INTRODUCTION

This short document from Willow Cottages residents [date 19 March 2018] is a measured and considered response to the recently submitted GEA authored BIA Audit Response document dated 24 January 2018.

The GEA BIA Audit Response is a formal reply to the additional queries raised in Campbell Reith's BIA Audit Report dated December 2017. It should be noted that to date the applicant under planning application 2016/7146/P [Proposed Basement works at 31 Willoughby Road NW3] has been afforded three opportunities to respond appropriately to the numerous and legitimate queries relating to the proposed works and their impacts on Listed Willow Cottages [LWC] and Listed Willow Cottages rear retaining boundary wall [LRRBW].

4K 17032018-001
SECTION C-C CORRECTED

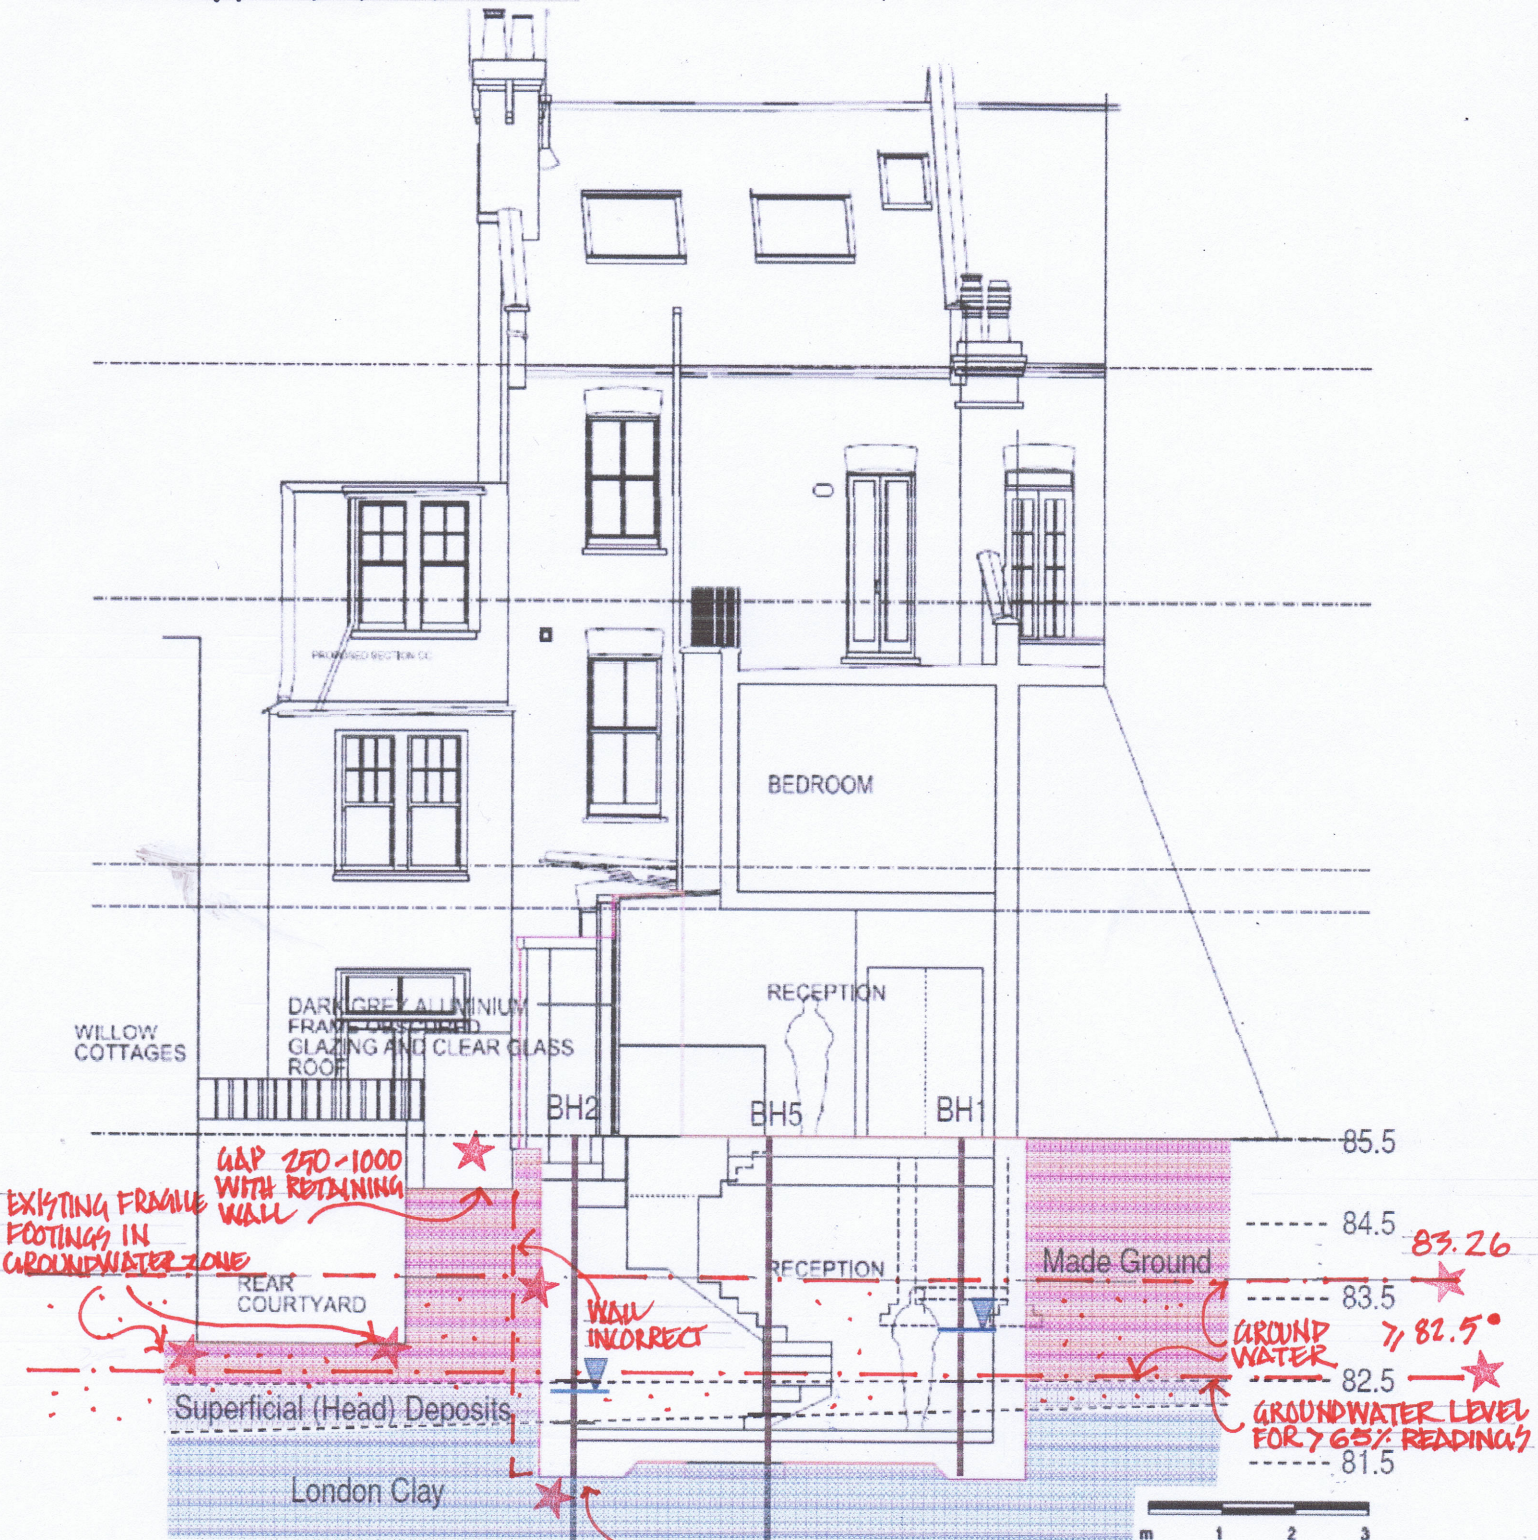
- Close proximity in that the closest distance between new 440mm thick basement RC wall to the listed Willow Cottages rear boundary retaining wall is approximately ONLY 250mm. This gap is impossible to achieve by basement construction methods without destroying the listed retaining wall. This risk location has not been identified.

Proposed Section C-C [shown on Page 2] is graphically incorrect and shows the relationship with Listed Willow Cottages and listed rear retaining wall in a more 'optimistic' manner that is dangerously misleading. The new proposed basement retaining wall, some 440mm thick, is not shown and the section position forming the drawing is located inappropriately at the widest part of the works from Willow Cottages. Section CC does not show the true and much closer works proximity to Listed Willow Cottages and the listed retaining wall as it makes the distance between Willow Cottages and Willoughby Road works far wider. Drawing 4186-SM02E shows the footprint proximity of the new proposed basement works relative to the listed Willow Cottages rear boundary retaining wall i.e. shows the closest distance of approximately 250mm. This unidentified risk location is impossible to construct whilst maintaining the structural integrity of the listed retaining wall!

SHOWING REAL PROXIMITY
RELATIONSHIP WITH REAR 38/39
WILLOW COTTAGES & RETAINING WALL

PROPOSED SECTION C-C - WITH COMMENTS RELATIVE TO WILLOW COTTAGES

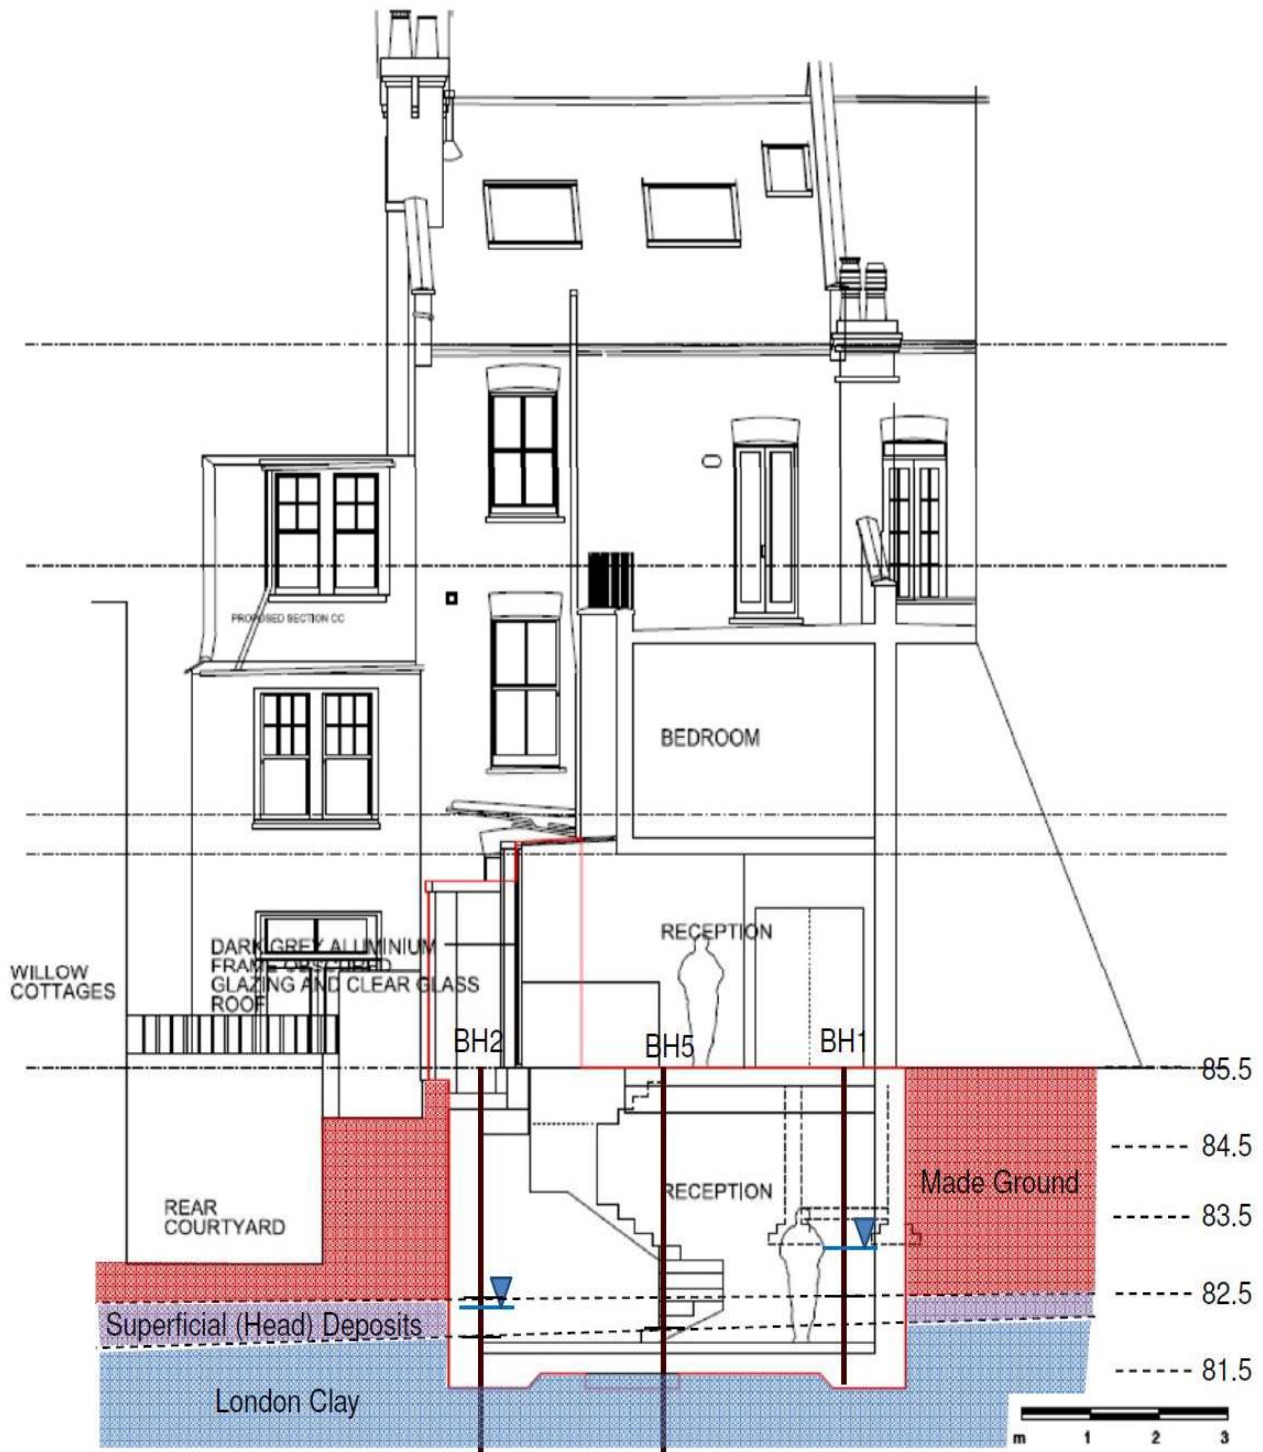
This same Section C C also excludes levels relative to Willow Cottages which would help identify these concerns and areas of risk raised by Willow Cottages residents.

This selective graphic underplays the real complexity of the proposed works impact on Willow Cottages and the listed retaining wall which the BIA neither acknowledges nor analyses.

REAL EXCAVATION DEPTH NOT SHOWN

EXTRACT DRAWING 4186-SMOZE

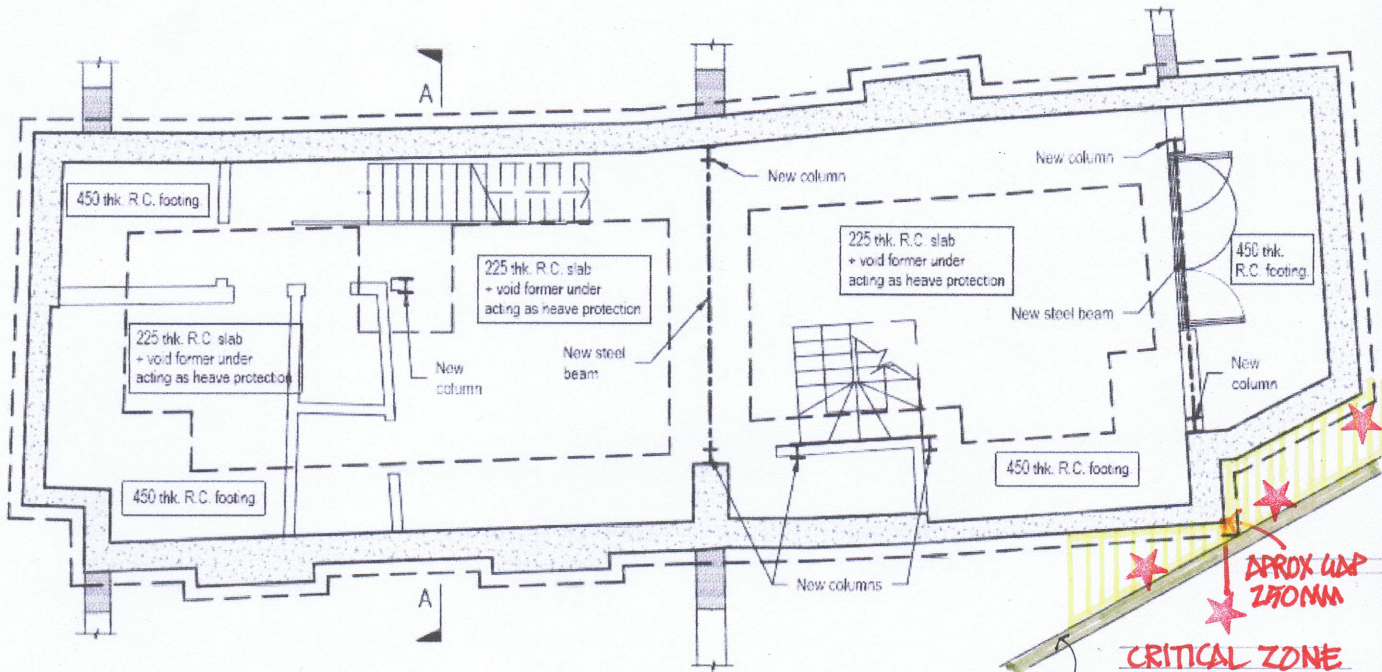
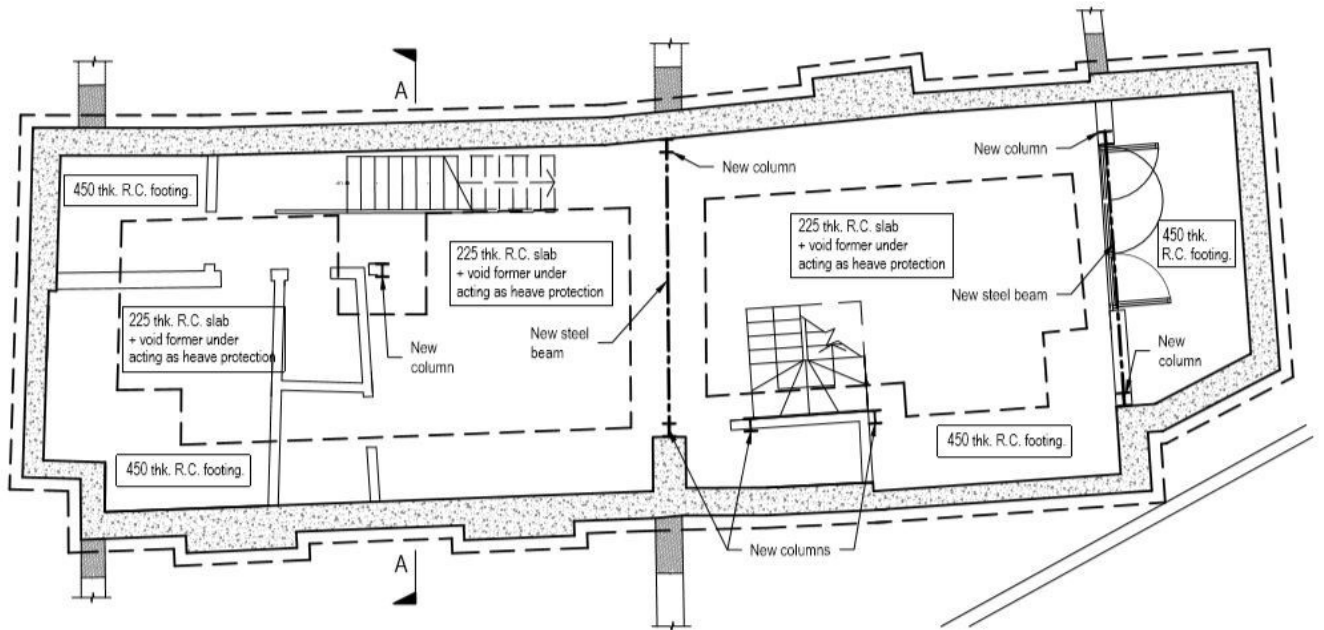
2. The combined summary drawings, including drawing 4186-SM02E and summary groundwater tables which all show their relationships to Listed Willow Cottages, ominously underplay and even ignore the real relationships and obvious impacts of

FOOTPRINT PROXIMITY - Not only are these depths damaging to the Listed Willow Cottages structures but are even more troubling when scrutinising Stage 3 and Stage 4 of associated Ungar Architects Drawing 'Suggested Method of Works 1' Drawing Number 4186-SM02E. This drawing clearly shows the footprint proximity of new concrete 440mm thick basement retaining walls to the Listed Willow Cottages rear boundary retaining wall as at worst approximately 250mm and at best approximately 1m. With constraints of both distance between structures and the fragile listed wall with flag footing, makes it impossible to build without substantial damage.

Combining footprint proximity with excavation depth below both Listed Willow Cottages rear boundary retaining wall and Listed Willow Cottages lower floor level, the spectre of real damage becomes obvious. This risk is made even worse when one adds the fact that although the excavations will go through the higher 3m deep 'Made Ground' level into a further approximately 1.5 m depth within the lower 'London Clay' layer, the ground water layer within the aquifer 'Made Ground' layer coupled with the hill slope places more hydrostatic pressure on the existing shallow and limited footings of listed Willow Cottages and rear listed retaining wall.
